REGULAR MEETING OF
THE PLANNING COMMISSION
JANUARY 21, 2021 AT 6:00
PM
ATTEND VIRTUALLY

1. **Case #2020-2924. Vista de La Sierra Final Subdivision Plat.** JenkinsGavin, Inc., Agent, for Branch Family Holdings, LLC, Owner, requests a final subdivision plat for a 393 single family residential lot subdivision. The property located at 3800 Governor Miles Road, is approximately 94.07 acres and is zoned R-5 (Residential-five dwelling units per acre). (Donna Wynant, AICP, Case Manager, djwynant@santafenm.gov, 955-6325).

C-102

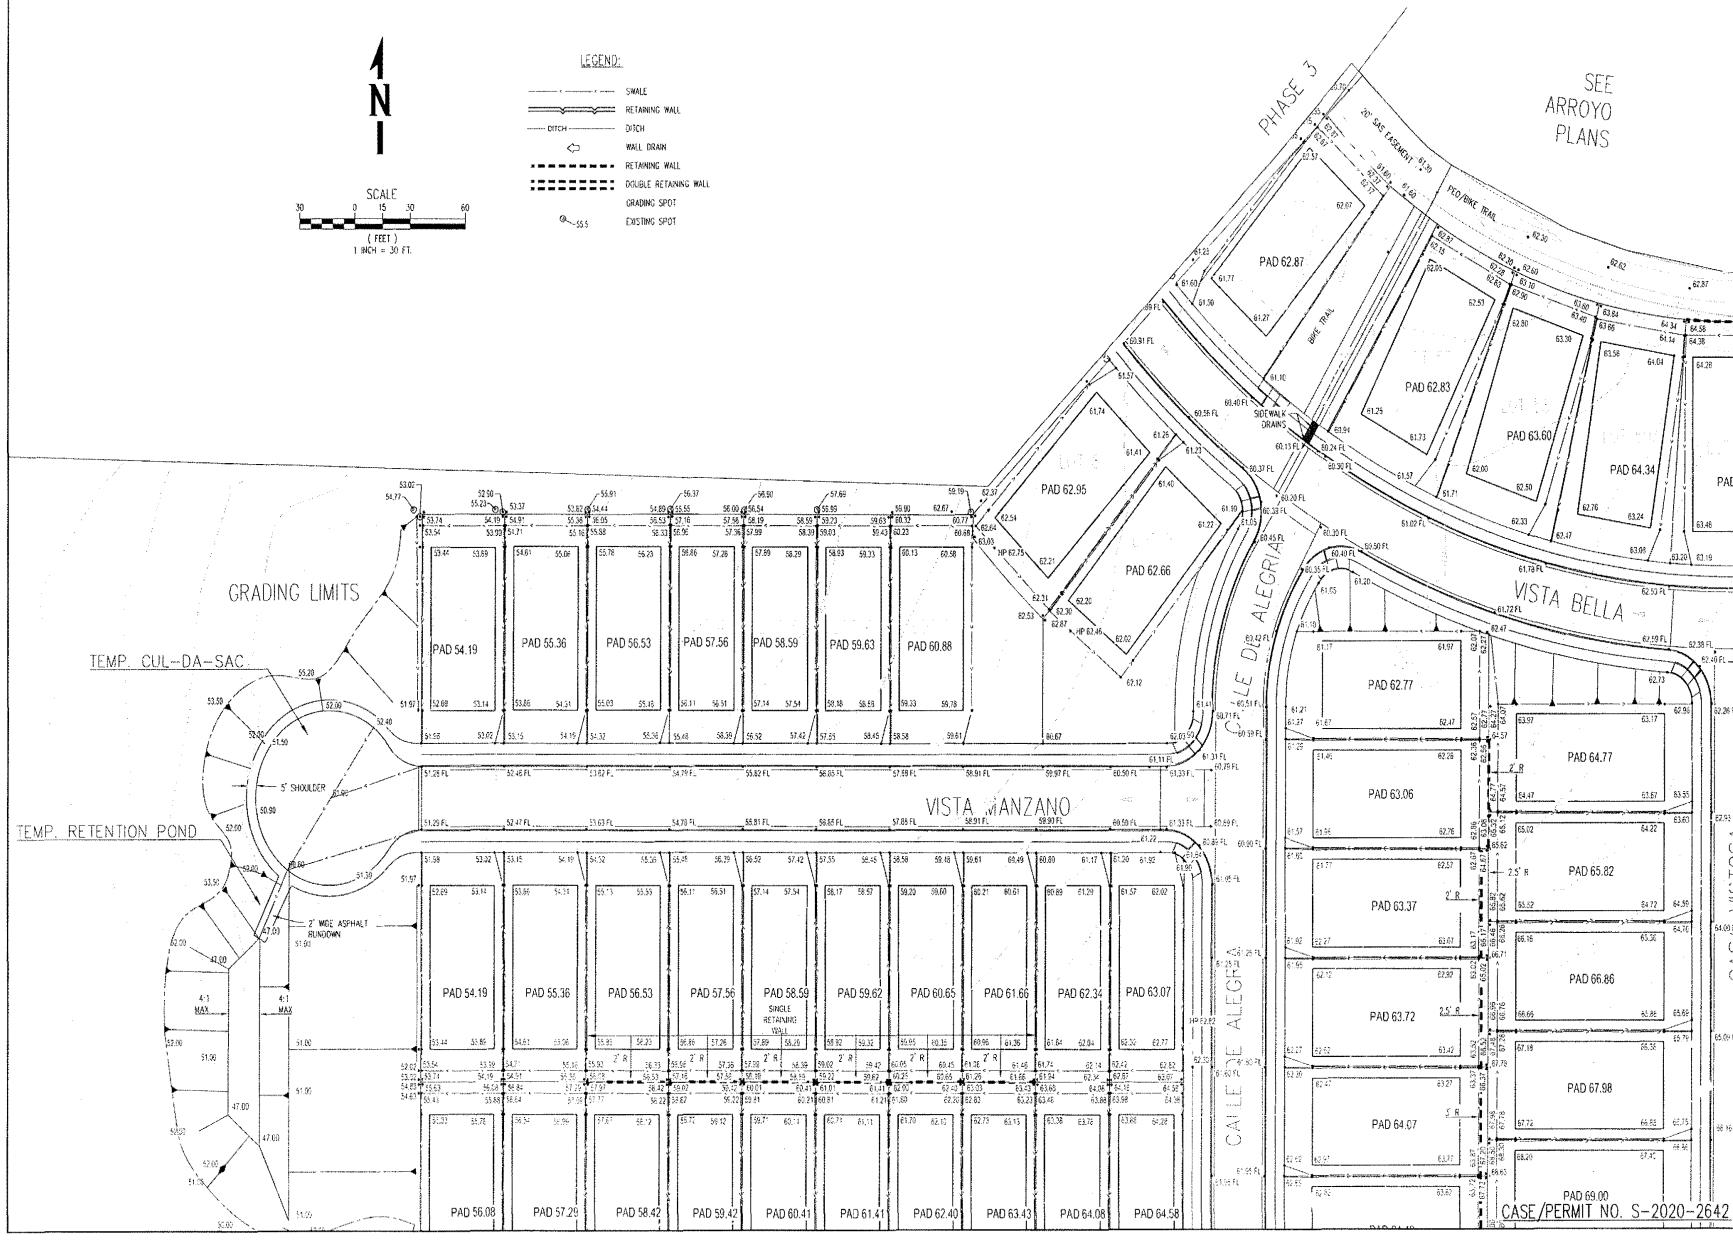
8. Sheet C1-102. Provide locations of ponds with overflows and proposed contours on all phases. Include, sections/details of ponds and overflows. Provide section/detail of temporary retention pond, reference sheet number. Label high points (HP) and elevations.

SHEET NO.
C1-105
 0 of 2

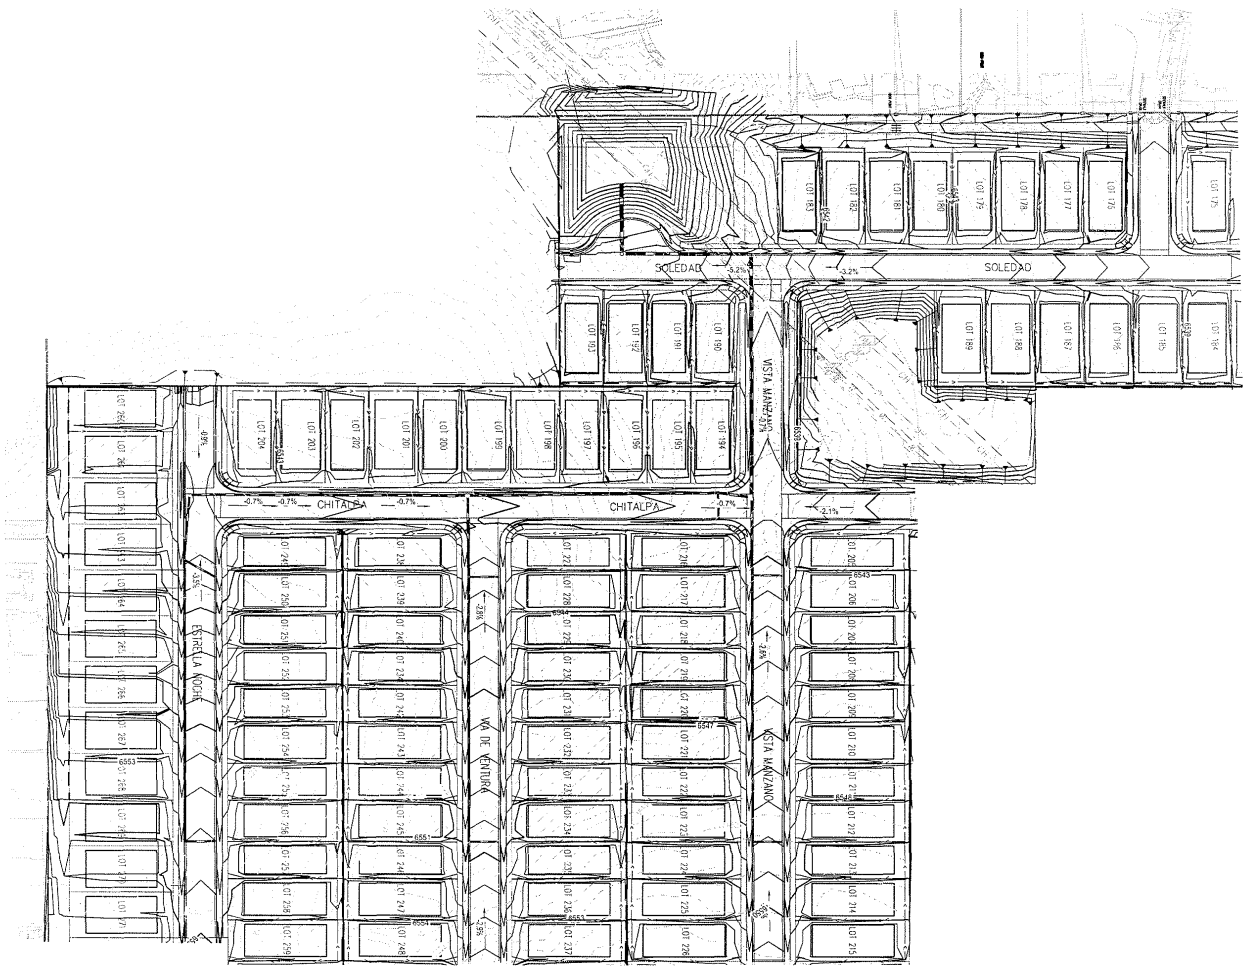
10. Sheet C1-104. Label high points (HP) and elevations and proposed pond numbers or letters.
11. Sheet C1-105. Label high points (HP) and elevations and provide detail of temporary emergency access.

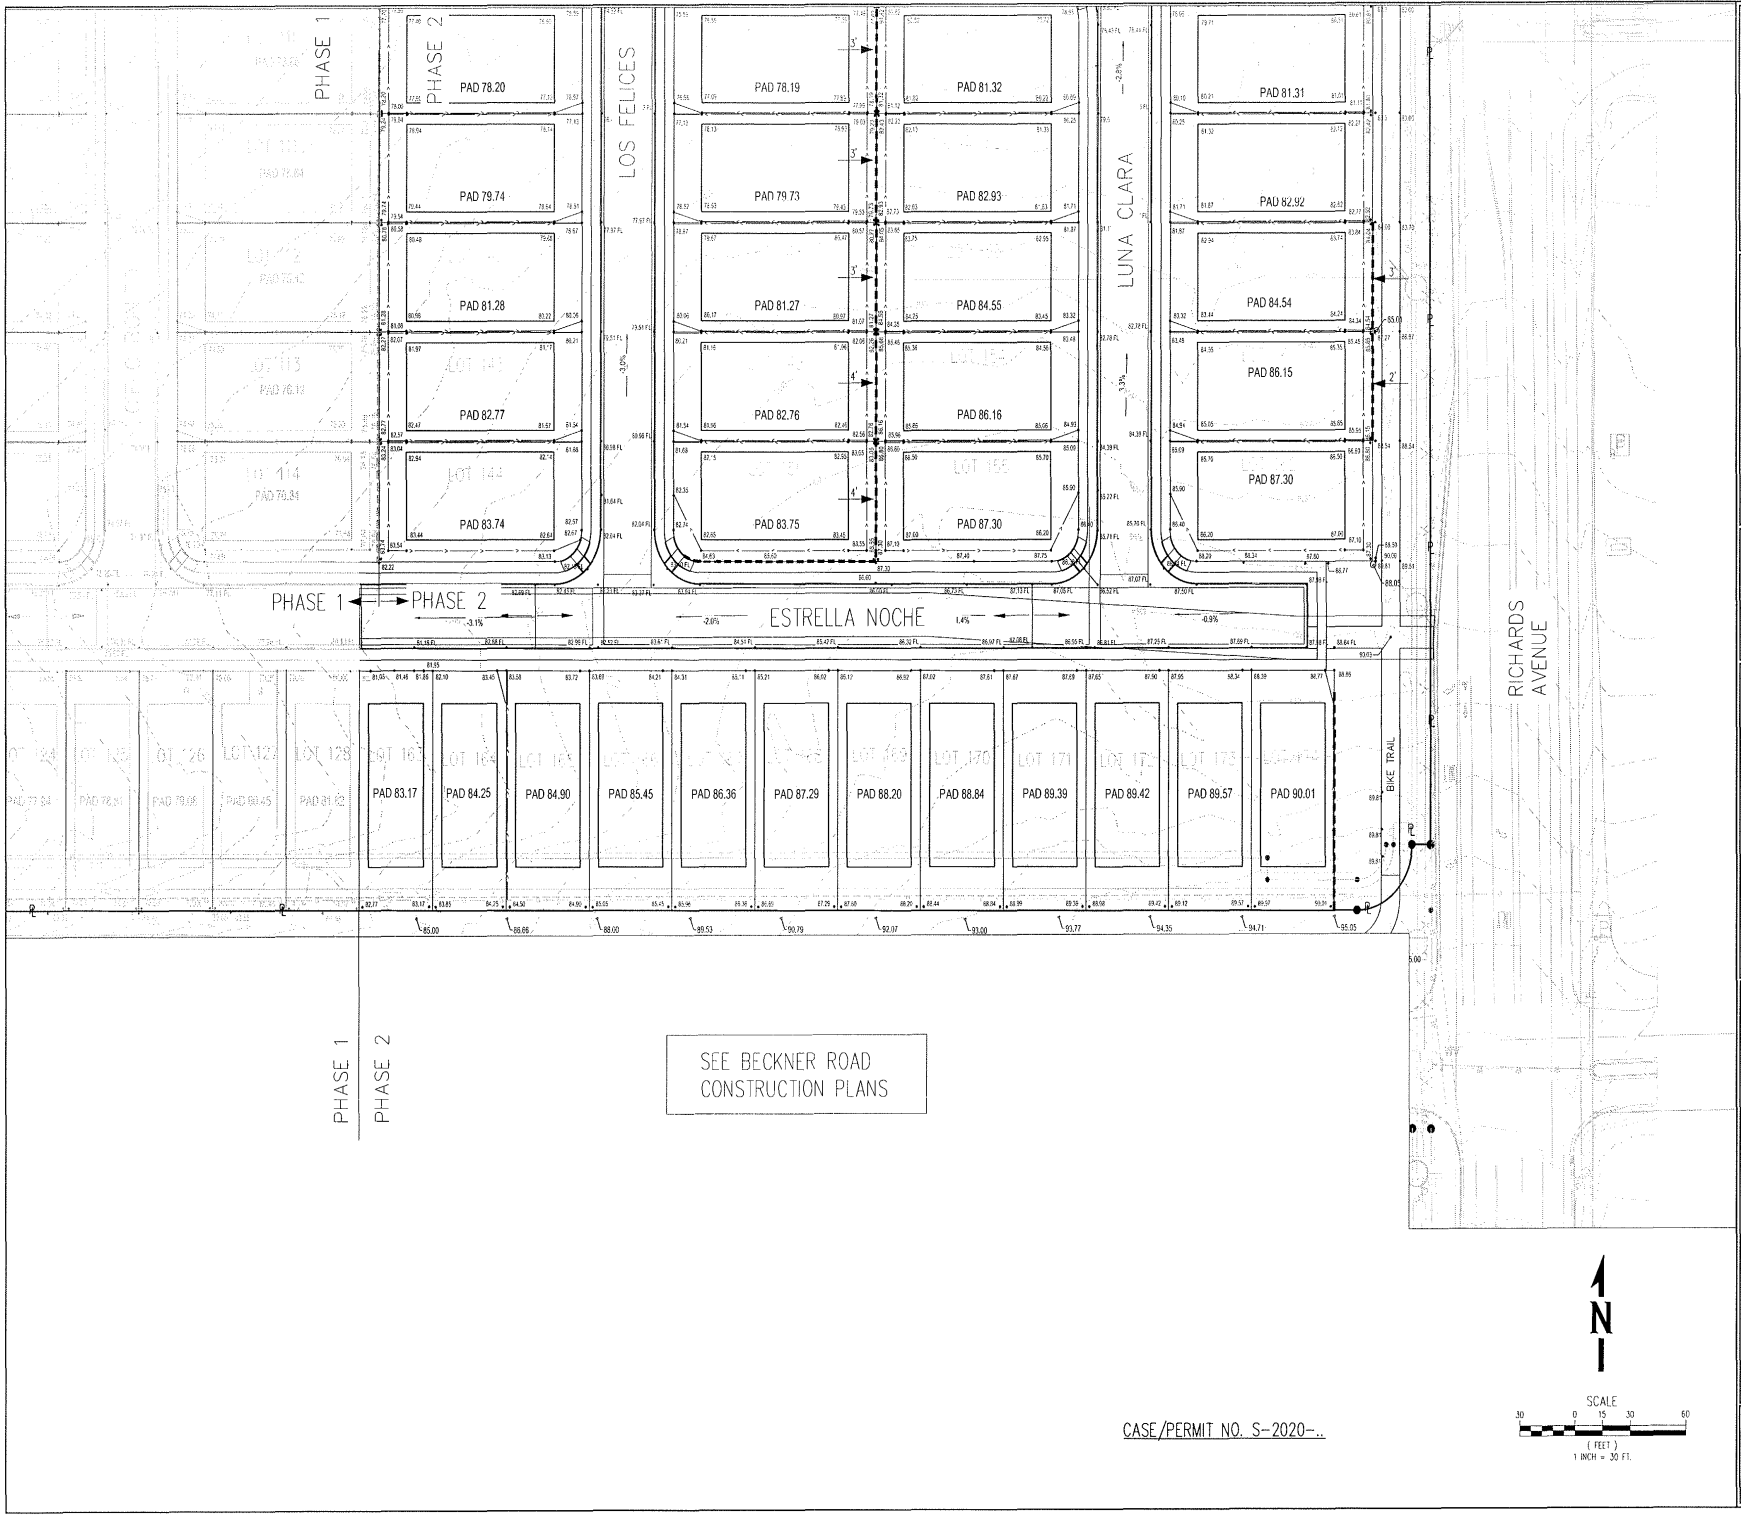
13. Sheet C2-101. Label high points (HP) and elevations of roadway. (PHASE 2)
14. Sheet C2-102. Label pond numbers. Provide correct sheet number for timber slope protection, provide and reference section/detail. Provide detail for proposed sidewalk drain or culvert. (PHASE 2)

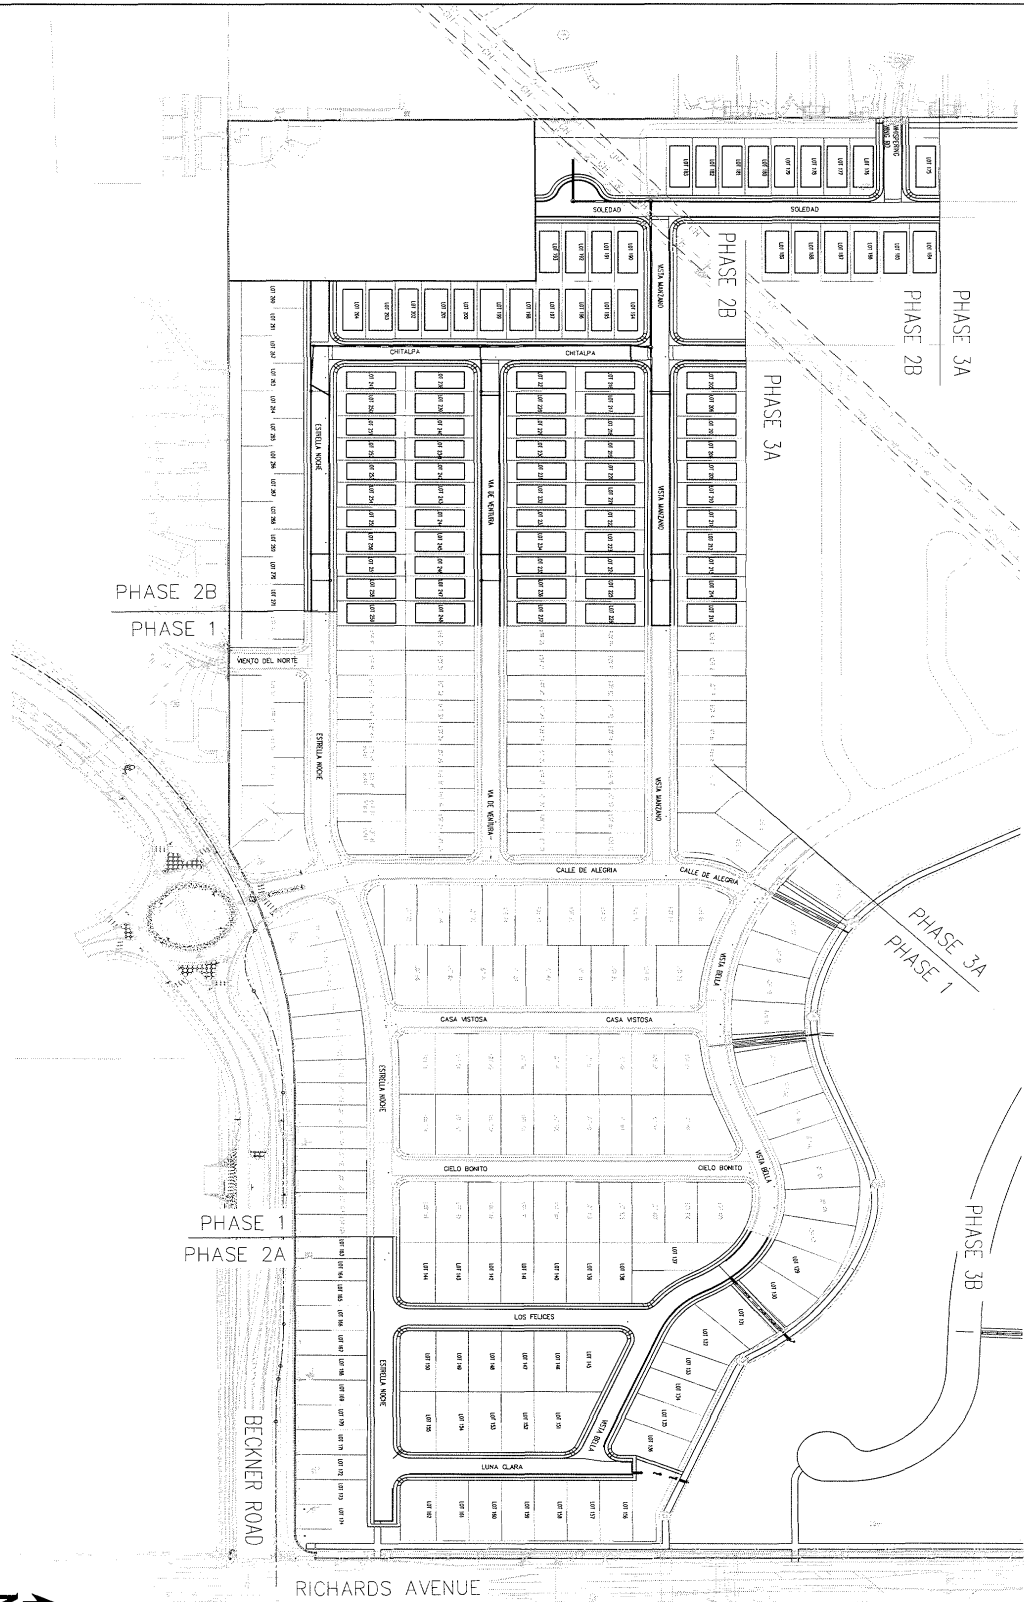
16. Sheet C1-200. Explain overall paving plan. Show and reference road sections for roadways, temporary cul-de-sacs and temporary emergency access road.

C-300

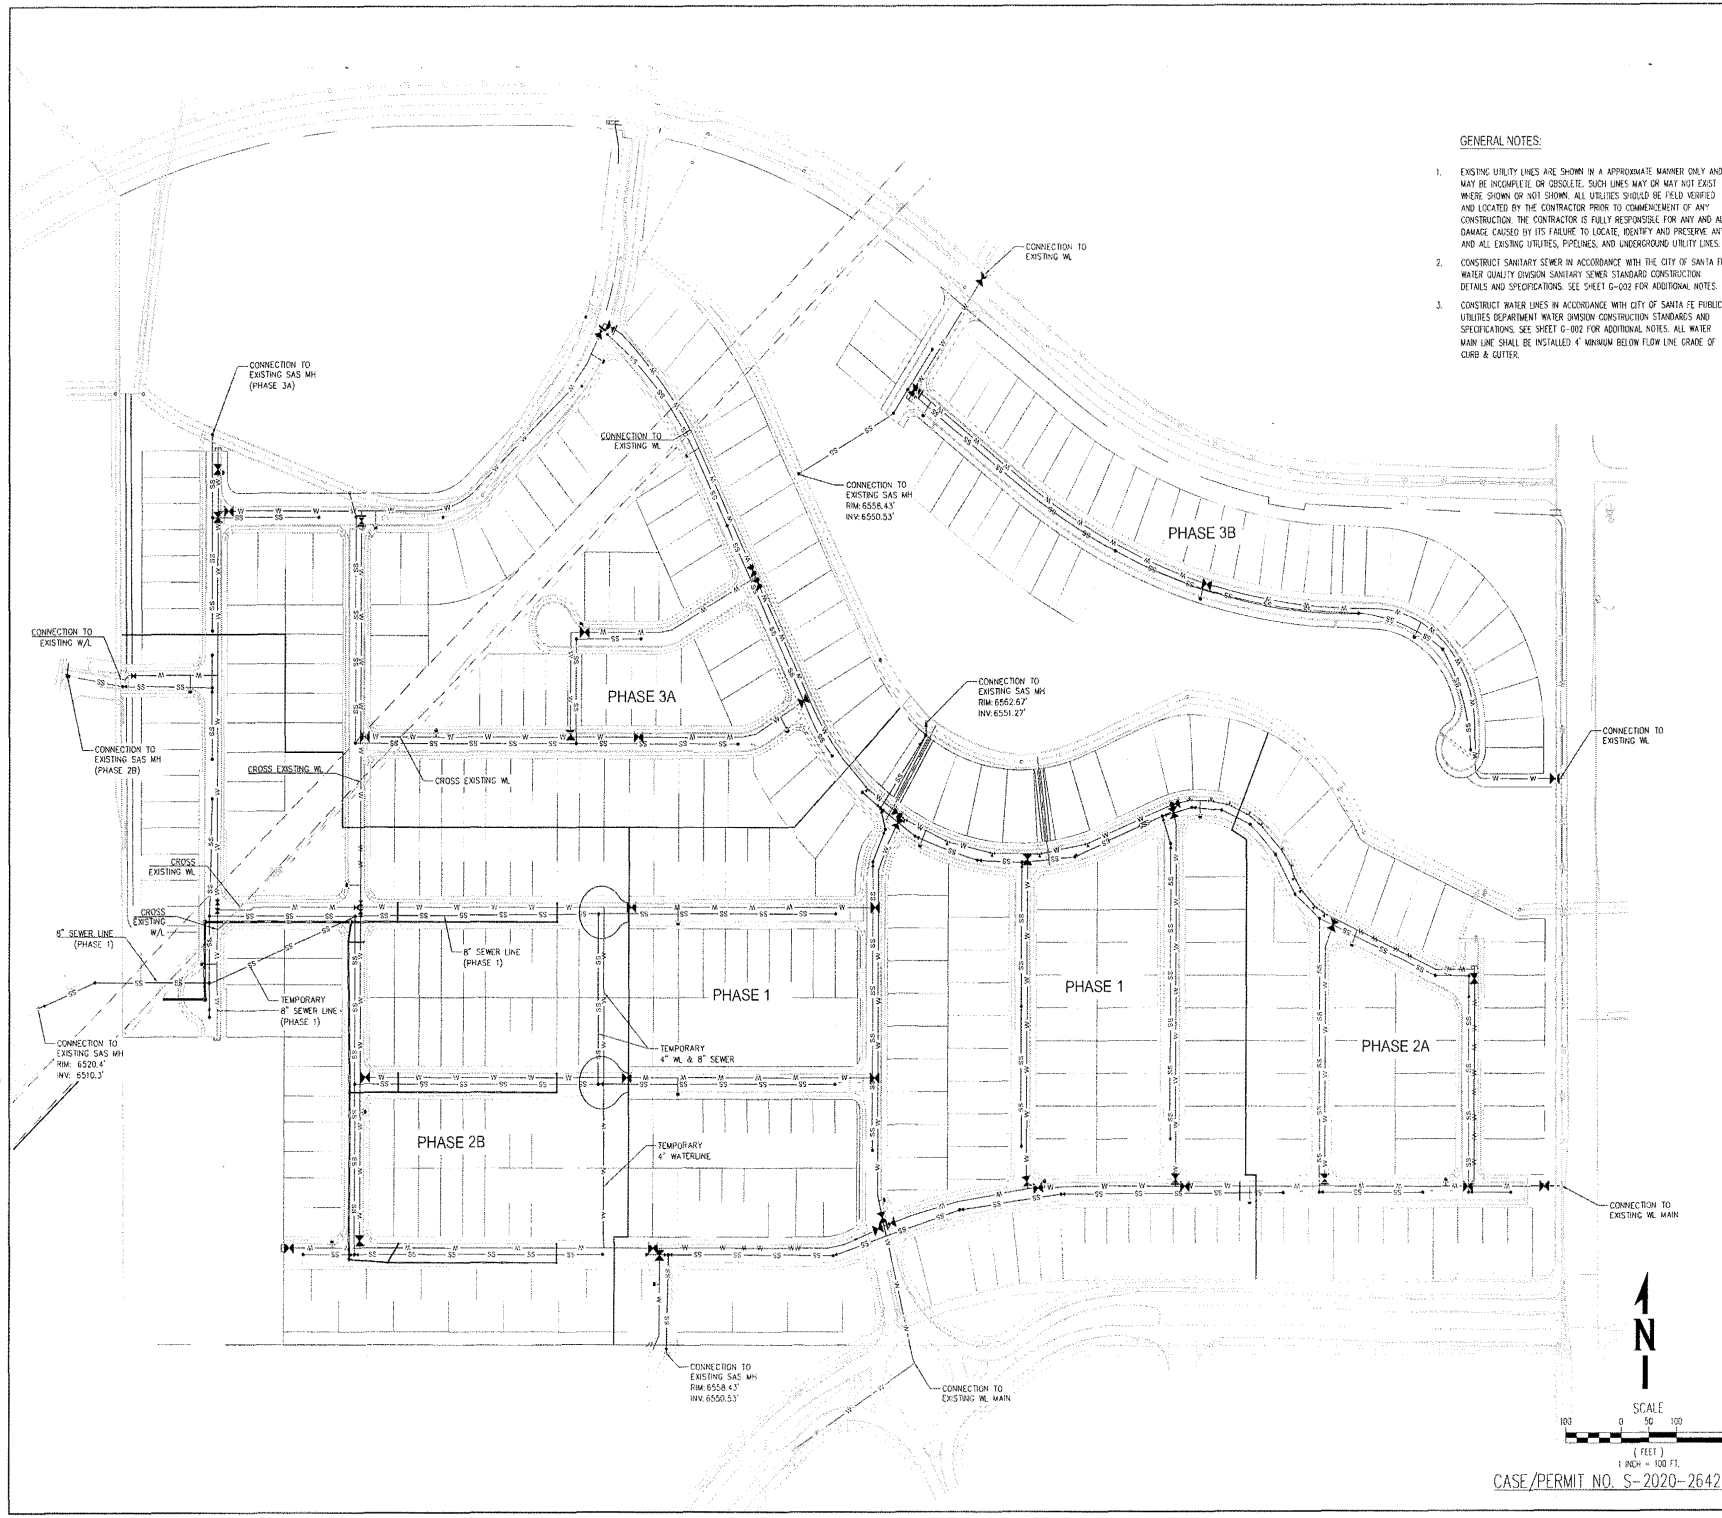
18. Sheet C2-212. Legend numbers need to correspond to proposed construction locations.
19. Sheet C-300. Indicated proposed round about location on Beckner Road.
